Proposal for amendments to Regulation No. 67 (LPG)
(new text is given in bold, deleted text is strikethrough)

A. PROPOSALS

Figure 3 (example only) ($a = 102$ mm; $b = 241$ mm)

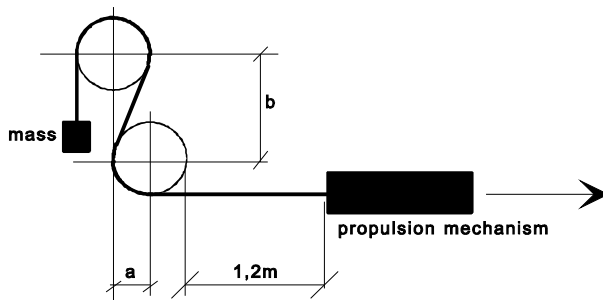
4.5.4.1. An empty hose, at a length of approximately 3.5 m must be able to withstand 3,000 times the hereafter prescribed alternating-bending-test without breaking. After the test the hose must be capable of withstanding the test pressure as mentioned in paragraph 3.5.5.2.

4.5.4.2. The testing machine (see Figure 3) shall consist of a steel frame, provided with two wooden wheels, with a rim-width of approximately 130 mm.

The circumference of the wheels must be grooved for the guidance of the hose. The radius of the wheels, measured to the bottom of the groove, must be 102 mm.

The longitudinal median planes of both wheels must be in the same vertical plane. The distance between the wheel-centres must be vertical 241 mm and horizontal 102 mm.

Each wheel must be able to rotate freely round its pivot-centre.

A propulsion mechanism pulls the hose over the wheels at a speed of four complete motions per minute.

4.5.4.3. The hose shall be S-shape-like installed over the wheels (see Figure 3).

The end, that runs over the upper wheel, shall be furnished with a sufficient mass as to achieve a complete snugging of the hose against the wheels. The part that runs over the lower wheel is attached to the propulsion mechanism.

The mechanism must be so adjusted, that the hose travels a total distance of 1.2 m in both directions.
